CHEVRON U.S.A. INC. INTENDS TO DEEPEN THE SUBJECT WELL. CHEVRON RESPECTFULLY REQUESTS A 1 YEAR APPROVAL.

SKELLY UNIT #948 DEEPENING PROGRAM

Skelly Unit 948
Chevron USA Inc.
30-015-32967
June 9, 2010
Conditions of Approval

Centralizer Diagram

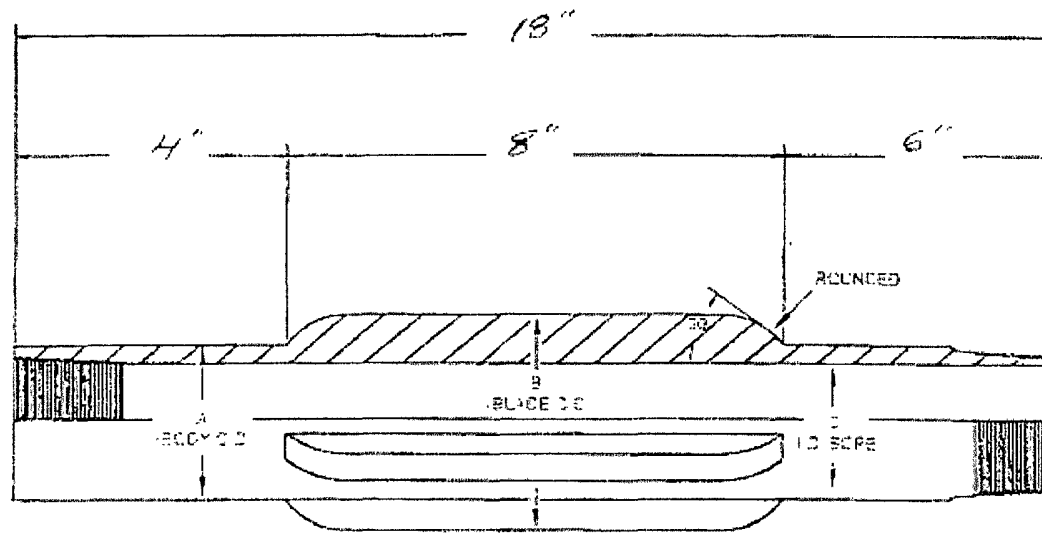
NOTE: CHEVRON USA INC REQUESTS A VARIANCE TO THE 0.422" STAND OFF RULE BETWEEN CASING AND WELLBORE.

Fixed blade stabilizer subs will be utilized in the casing string to insure adequate isolation and seal throughout the wellbore. These stabilizer subs are positive fixed blade type. These subs will actually be screwed into the casing string. A diagram of the fixed blade stabilizer sub is located at the end of this program.

5. BOP to be tested to **1000 psi** based on BHP expected.
6. Variance for stand-off of less than 0.422" is approved due to NMOCD classifying the formations in this area as the Yeso group.
